STTC Design Commission Presentation

PEDESTRIAN BRIDGE MITIGATION

Responses to Commission

PROPOSED NORTH/SOUTH/& EAST ELEVATION MODIFICATIONS
SCALE: 1/16" = 1'-0"

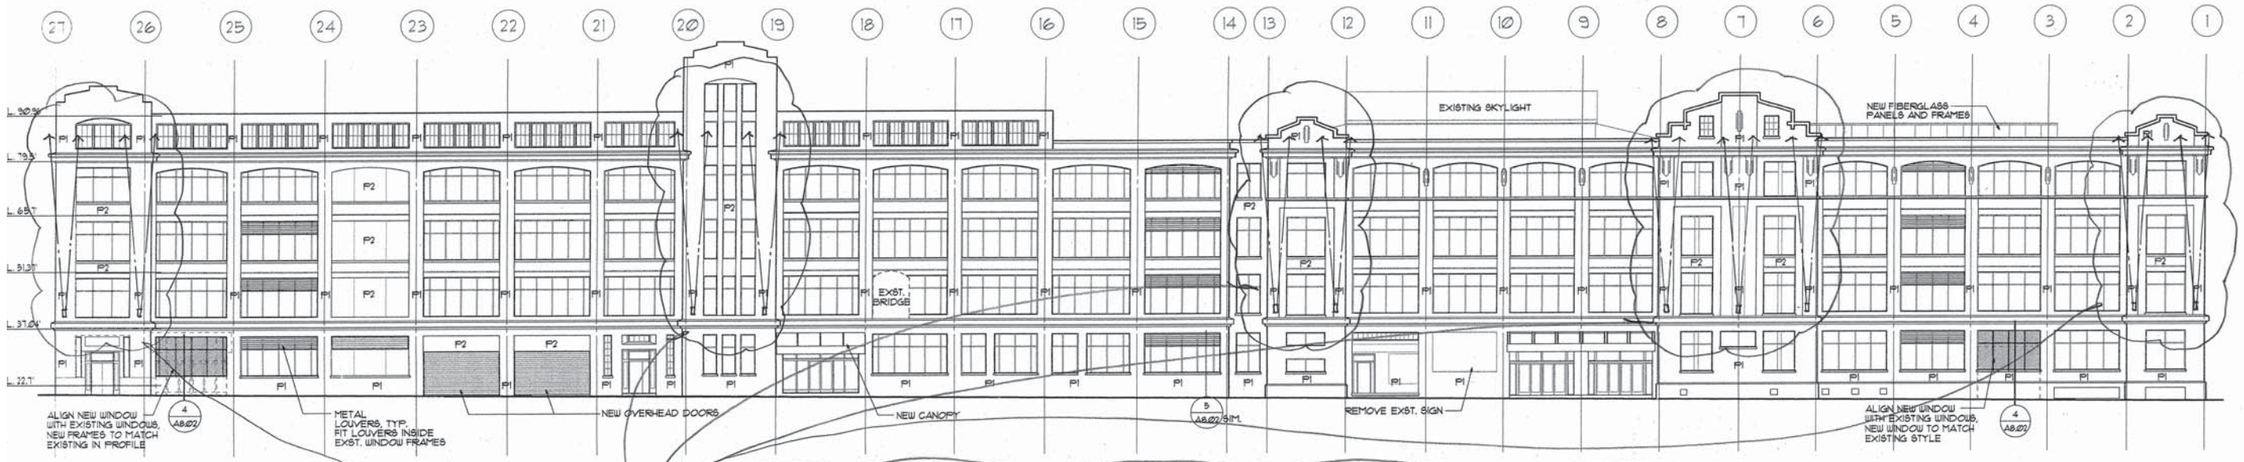
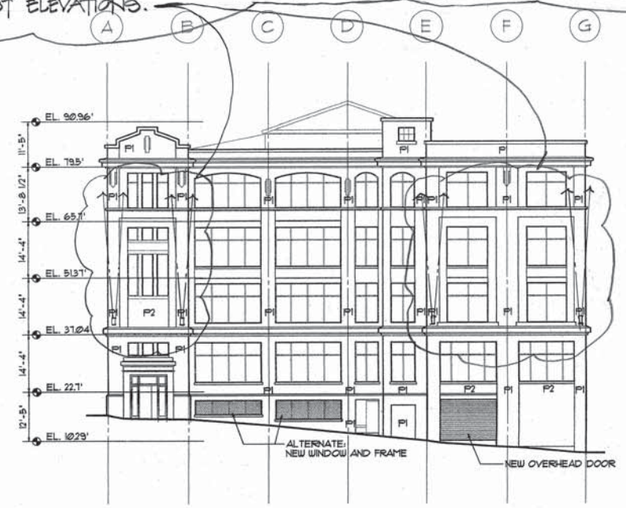
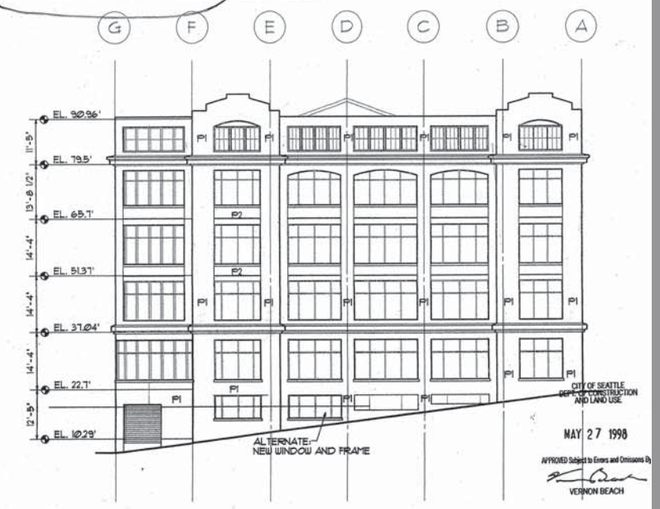
The proponent is asked to please consider in more detail conditions at day and night, and on both sides of the street.
In addition to the lighting of the building, the pedestrian bridge, and the garage stair tower lantern (all night elements), the design team has incorporated a combination of paint, decorative panels and art displays at the garage. On the east side of the street an effort was made to remove existing film at blackout windows, replacing it with etch-matt film (allowing light to spill out from the interior), for a more desirable pedestrian experience at the south end of the building.

Consider using color in the overall concept.
Our intent is to have some flexibility of color at the sky bridge and the garage stair tower. Given the existing architecture of the STTC building, it is inappropriate to uplight with color, so we would install lighting that will accent the strong elements of this building as they were originally intended. At the art display cases we would want to maintain a neutral light that does not change or distract from the artist's true intent of each piece.

REPLACE EXISTING UPLIGHTING FIXTURES WITH NEW LOW ENERGY LIGHTING TO RE INTRODUCE ICONIC MARKERS ON NORTH, SOUTH & EAST ELEVATIONS.

NOTE: BACK PAINTED GLASS ALONG ELLIOT AVE. TO BE MODIFIED/TO BE BACKED WITH TRANSLUCENT ETCH-MATTE FILM & INTERNALLY ILLUMINATED

A PROPOSED SECTION @ DISPLAY CASE
SCALE: 1" = 1'-0"

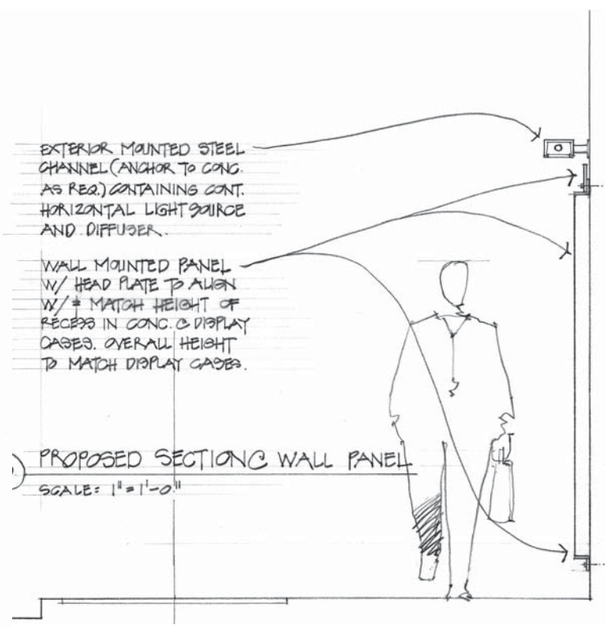
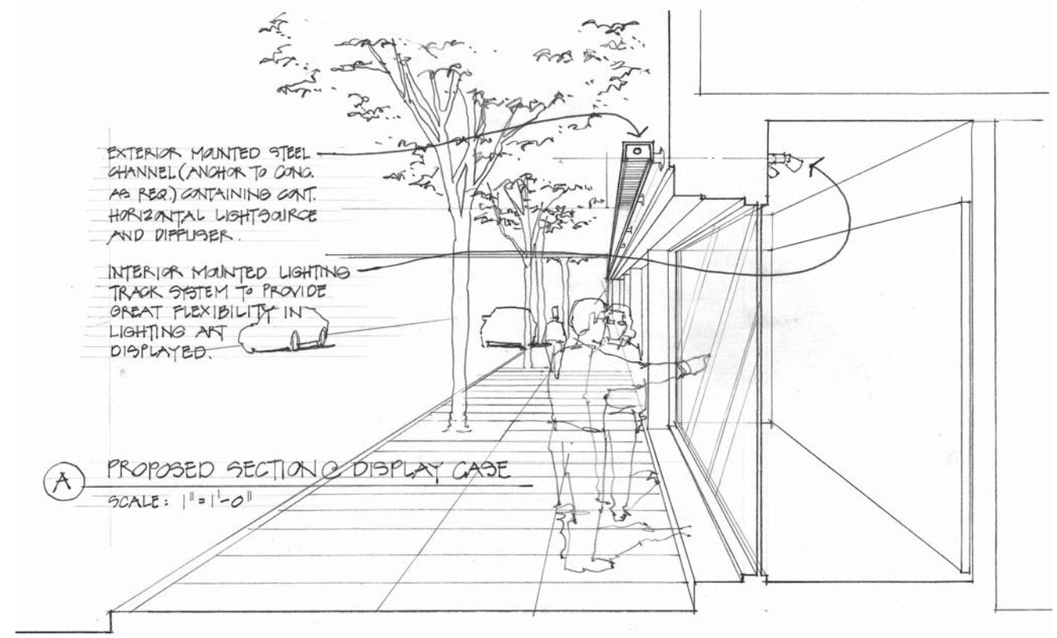
Commissioners found the proposed lighting colors interesting and would encourage the team to consider the daytime visual experience, not just the night time lighting.
In addition to the lighting, the design team is addressing the daytime visual experience by adding art displays that will be managed and maintained by the Art Institute. We have discussed this space with the Art Institute and they are excited about the opportunity. Architectural panels at the street level of the garage will create visual interest beyond the art displays and both elements will be offset by a contrasting paint color.

The display cases are seen as having great potential. Commissioners ask that the designers explore with RealNetworks and the Art Institute the possibility for lively, dynamic solutions that express the visual, aural and technological nature of what is contained in the buildings.
We have met with the curator of art from the Art Institute and have begun initial conversations regarding the type of art, the rotations and potential exhibits. We are very excited about this opportunity as a long term solution for generating an interesting pedestrian experience. RealNetworks is a provider of visual entertainment and while attempting to integrate technology is a novel idea, the RealNetworks site is not the medium that fits within their marketing strategies.

PROPOSED GREEN SCREEN @ GARAGE
NO SCALE:

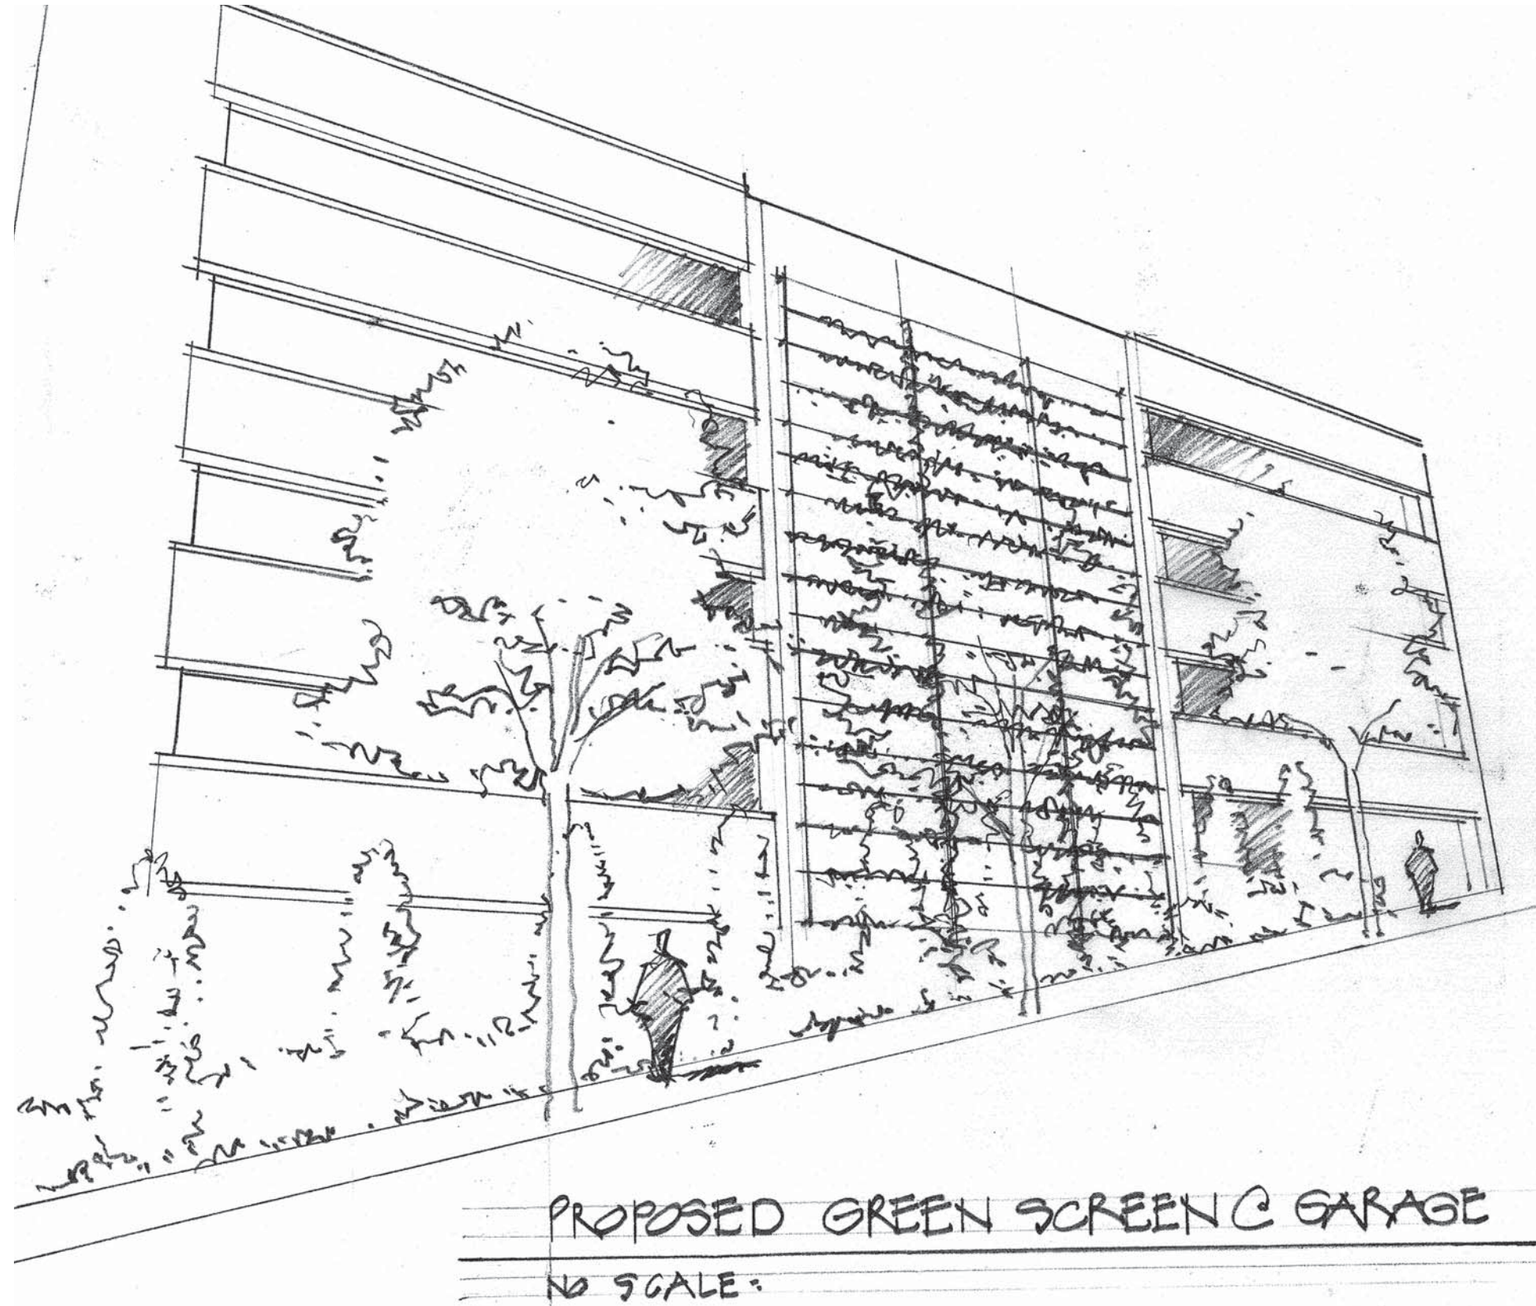
While the Commissioners understand the challenge of the lack of sunlight along the street, they encourage the design team to consider how landscaping can be added to the streetscape.
Due to the width of the sidewalk on both the east and west side of Elliott, we have determined that there is not enough room to add to the landscape. Currently there are very large street trees that line both sides of the street providing a very strong landscape element. In addition to the street trees, a landscaped area has been added to the north side of the garage along Cedar, featuring seasonal color and rock formations. On the south end of the building along Vine, we are proposing an enhanced landscaped area that adds seasonal color and potentially a green screen of vines that connects to the pea patch. This space is also somewhat limited.

℄ ELLIOT AVE.
C
8 PANELS HUNG IN STRUTURAL FRAMEWORK OF BRIDGE & ACCENTUATED IN THE EVENINGS W/ INTERNAL ILLUMINATION.
PROPOSED REFLECTED CEILING @ BRIDGE
SCALE = 1/4" = 1'-0"

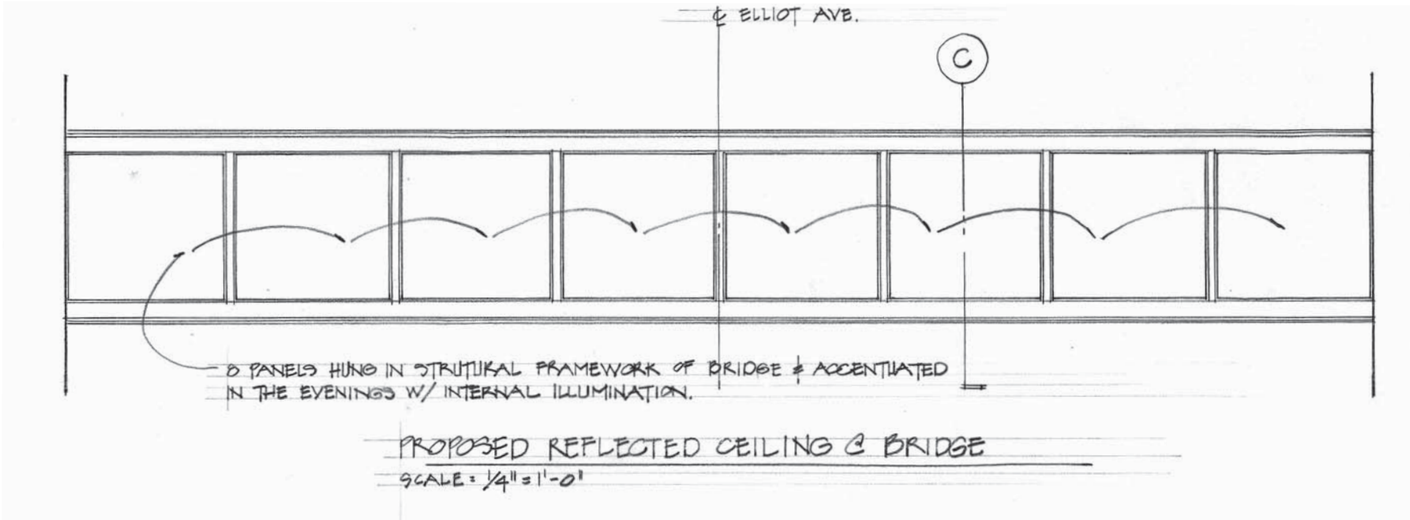
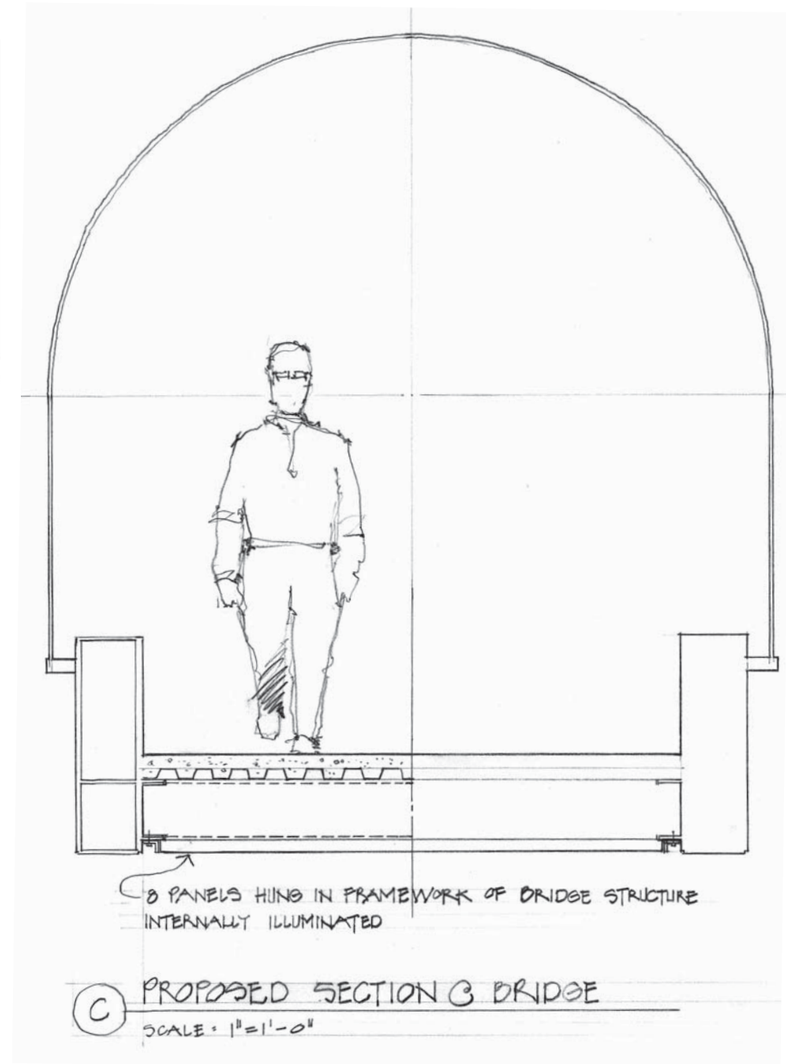
Consider lighting the skybridge element differently than the buildings.
The intent of the design team is to provide backlit panels that will be flexible in color.

8 PANELS HUNG IN FRAMEWORK OF BRIDGE STRUCTURE INTERNALLY ILLUMINATED
C
PROPOSED SECTION @ BRIDGE
SCALE = 1" = 1'-0"
